SUMMARY OF CHANGES TO PARKING GARAGE STRUCTURE ELEVATIONS AND LANDSCAPING:

EARL STEWART TOYOTA
LAKE PARK, FLORIDA

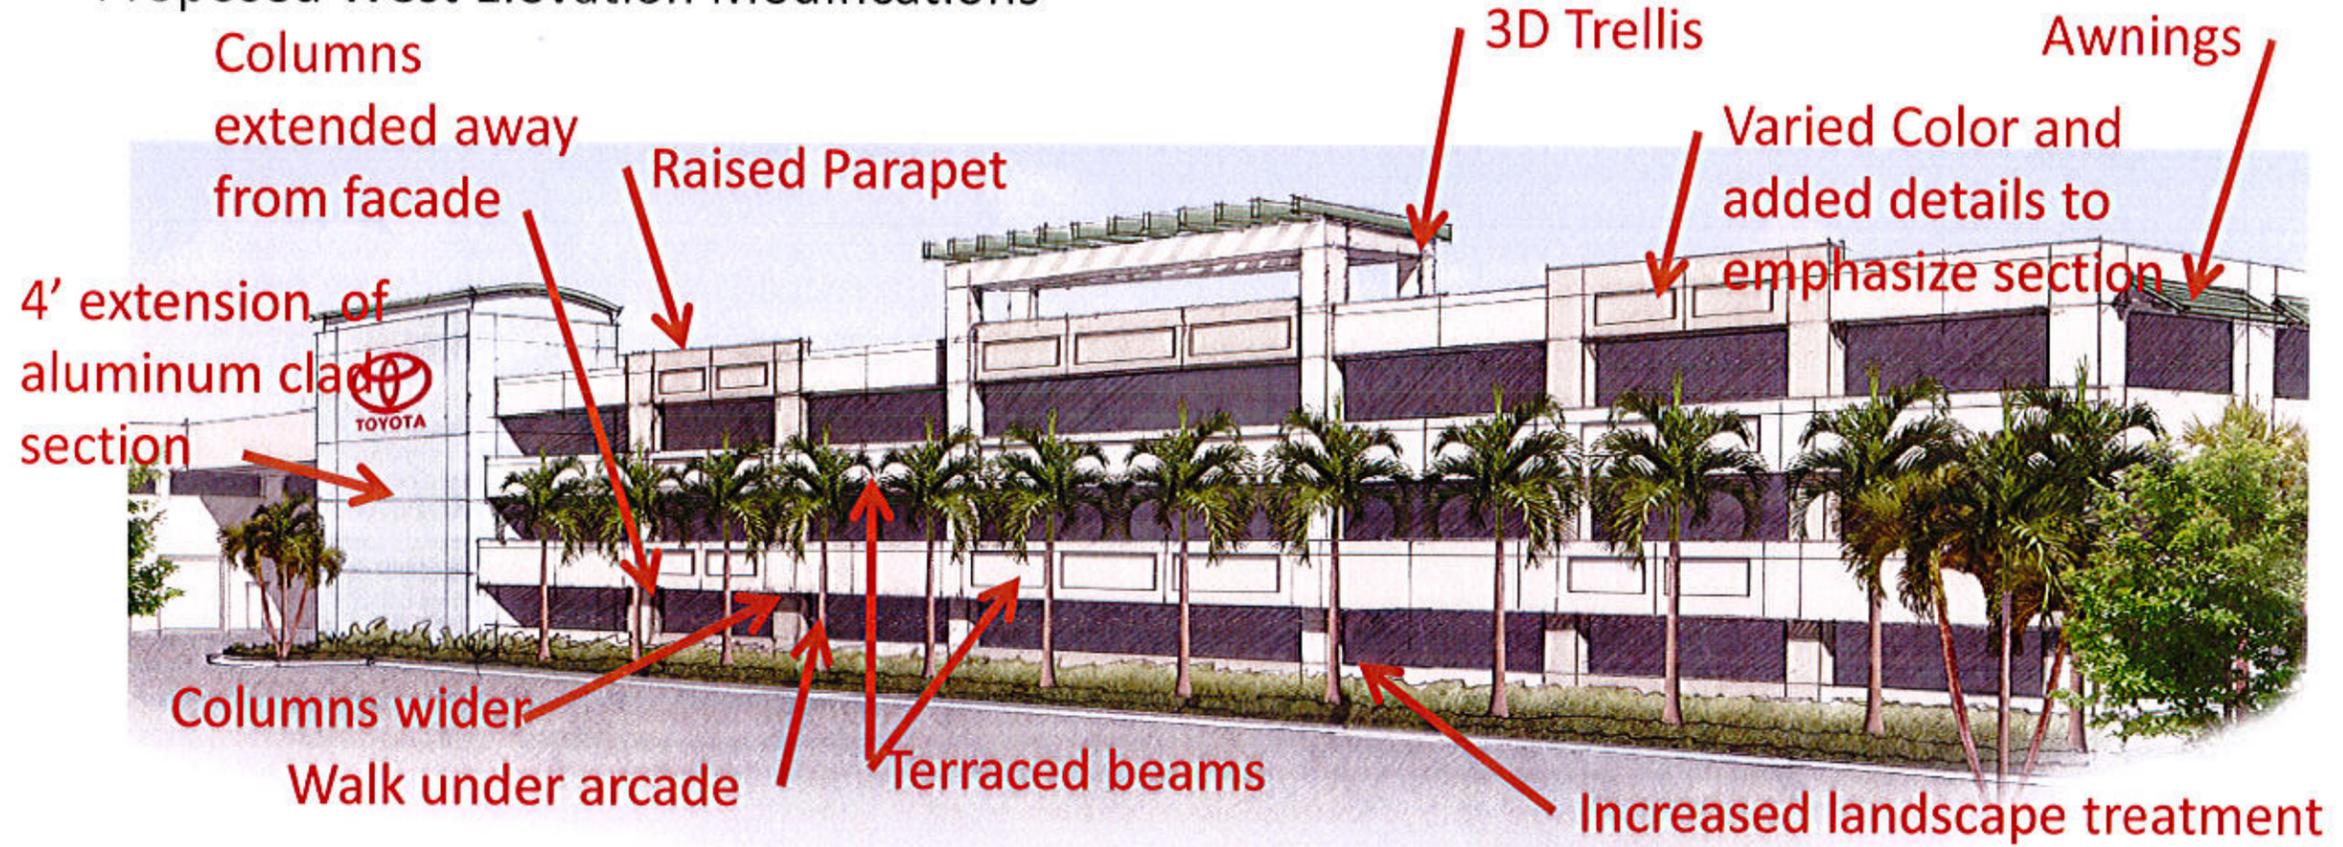
- a. Horizontal beams at various depths have been added to the west façade to provide a terrace effect. These beams will create variation in the façade, shade and a greater depth of articulation to the west façade. The east elevation will continue to provide a heavy landscape buffer at the lower levels and awnings at the upper level.

- b. An alternate color has been added to the full vertical height of the façade sections that have raised parapets. The color is intended to reinforce the changes in depth created by the horizontal beams and to reinforce the variation of column width on the East, South and West Façades.

- c. The vertical columns have been increased in width to reduce the opening size of the ventilation openings, and increase the definition of the column.

- d. The vertical columns have been extended away from the façade by 20" to create a vertical terracing effect and to reinforce the terracing effect of the horizontal beams.

- e. The aluminum clad elevator shaft/stairwell has been extended by 4' to allow the beams to terminate into a wall and to create an arcade walkway.
